Recall Campaign: Replace Hex Bolt with Internal Thread for Deflection Pulley

E70 with M57Y engine

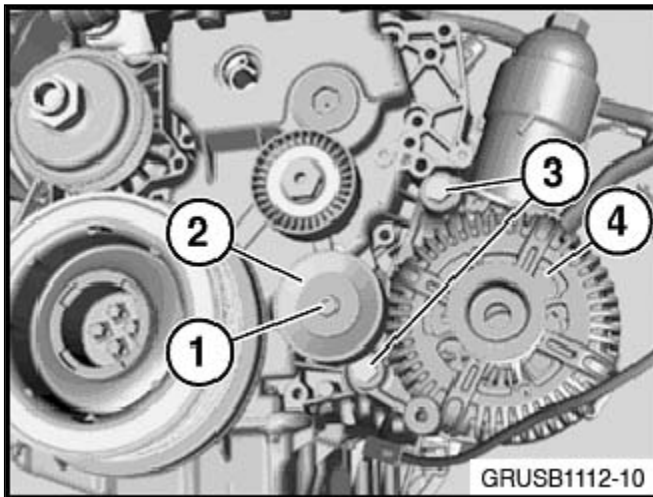
One of the alternator attaching bolts may fail. Subsequently the vehicle may lose power steering assist while driving. If power steering assistance is lost, the vehicle will remain controllable through the mechanical steering system, but with increased steering effort.

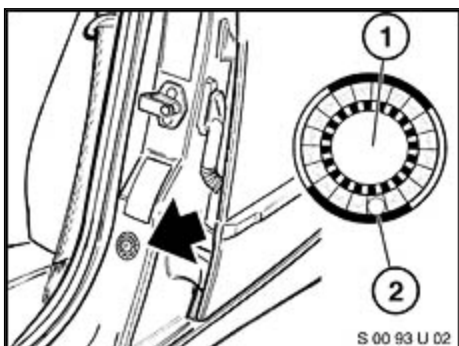
3. Remove cover (1) from Deflection pulley (2) to access the mounting bolt. Remove the deflection pulley (2).

4. Replace the alternator and deflection pulley mounting bolt with P/N 12 31 8 574 809.
5. Torque the bolt to 38 Nm initial torque and then angle torque the bolt an additional 180°.
6. Reassemble the vehicle.
